Airworthiness Directive Schedule

Cessna 150 and 152 Series

29 September 2011

Figure 1
Mid-America Dwg No.1001
(STC SA1371 SW)

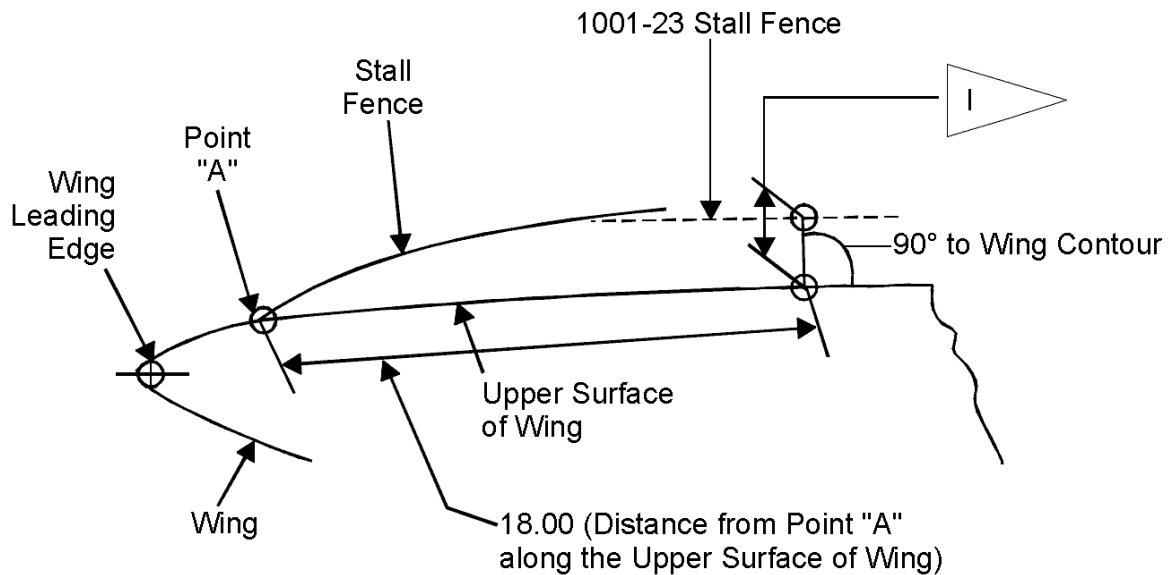
- Applicability** Model 150 series, A150 series, 152 and A152 fitted with a Bush Conversions Inc, Short Takeoff and Landing (STOL) kit per STC SA1371SW.
- Requirement:** To prevent the aircraft entering a stall condition because of improper wing stall fence height which could result in loss of control of the aircraft, accomplish the following:-
Measure the height of the wing stall fence at its trailing edge to ensure that its height does not exceed 1.28 inches. (see diagram).

If Stall Fence is 1.16 ± 0.12 High
that is correct height for Cessna 150/152.

If Greater Than 1.28 high
Remove Stall Fences and Install the Correct One.

If the height of the wing stall fence exceeds 1.28 inches, prior to further flight, install a smaller fence in accordance with instructions obtained from the Civil Aviation Authority.
